Access Compliance Report

Public Rights-of-Way

Intersection ID: 50272	Main Street: SOUTH_BV	Cross Street: WHITTON_ST	Location: SW
ADA ID: 9E93B19FE900	Ramp Type: BlendTrans1	Initial Pass/Fail: Pass	Overall Compliance: No
			Severity Score: 2.5

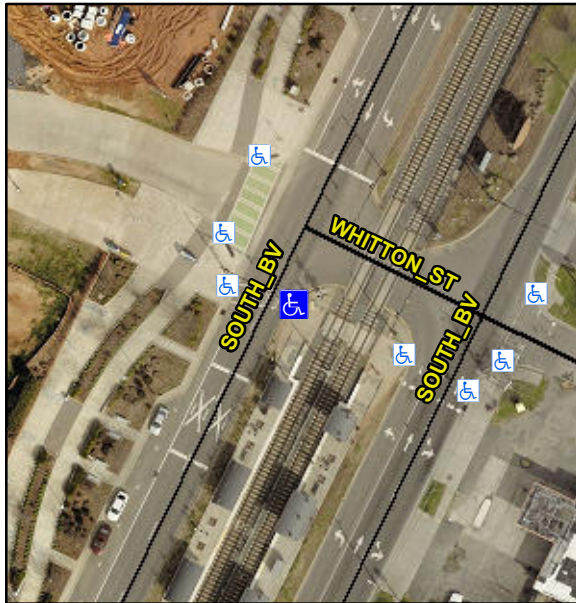
R305.1.4

Remove & Replace Detectable Warning System.
